SUBJECT: DIABLO CANYON POWER PLANT, UNIT NO. 1 AND UNIT NO. 2 –
ISSUANCE OF AMENDMENT – REVISION OF TECHNICAL SPECIFICATION
(TS) TABLE 3.3.1-1, "REACTOR TRIP SYSTEM INSTRUMENTATION," AND
REVISED REACTOR COOLANT SYSTEM FLOW MEASUREMENT (TAC NOS.
MB6760 AND MB6761)

SAFETY EVALUATION BY THE OFFICE OF NUCLEAR REACTOR REGULATION
RELATED TO AMENDMENT NO. 161 TO FACILITY OPERATING LICENSE NO. DPR-80
AND AMENDMENT NO. 162 TO FACILITY OPERATING LICENSE NO. DPR-82
PACIFIC GAS AND ELECTRIC COMPANY
DIABLO CANYON POWER PLANT, UNITS 1 AND 2
DOCKET NOS. 50-275 AND 50-323

The reproduced Figure 6, to the right, provides a similar comparison of N-16 and elbow tap flow rates for a third plant. Again, the elbow tap data appear somewhat more stable than the N-16 indications, but overall there is little variation.

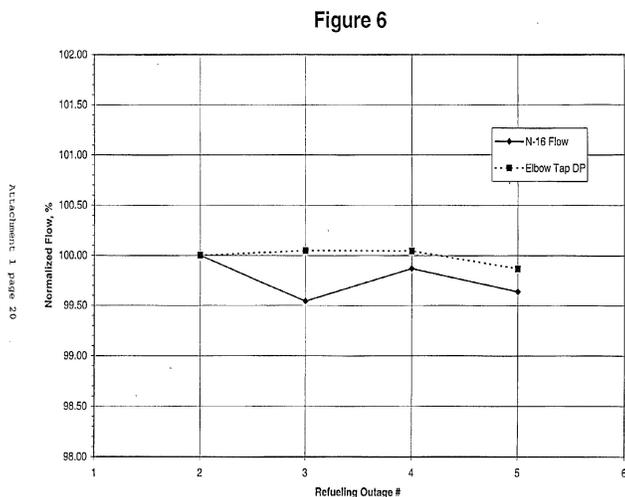
There is no evidence of a long-term change in the elbow tap indications in comparison to the N-16 indications and the data generally substantiate that the elbow tap flow coefficients remain constant with increasing time.

Based on the above evaluation, the staff finds that the elbow tap flow meter coefficients remain sufficiently constant that the relative changes of flow rate through the cold-leg elbows can be correlated with the relative changes in the elbow tap ΔP s.

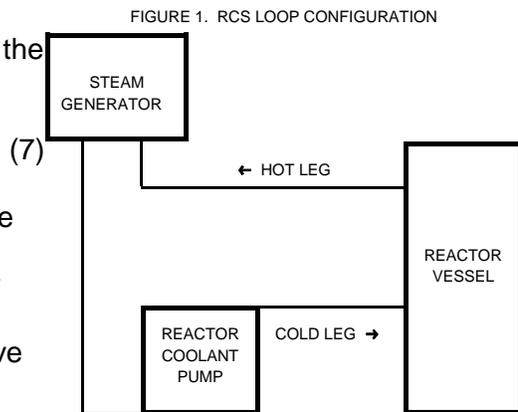
The RCS configuration illustrated in Figure 1 is used as a basis for flow rate analyses. An overall heat balance is taken over the control volume defined by the surface of the RCS to obtain Equation 7:

Since Q_{cal} is determined from the calorimetric, and Q_{loss} and Q_{RCP} can be estimated, this equation will provide Q_{core} .
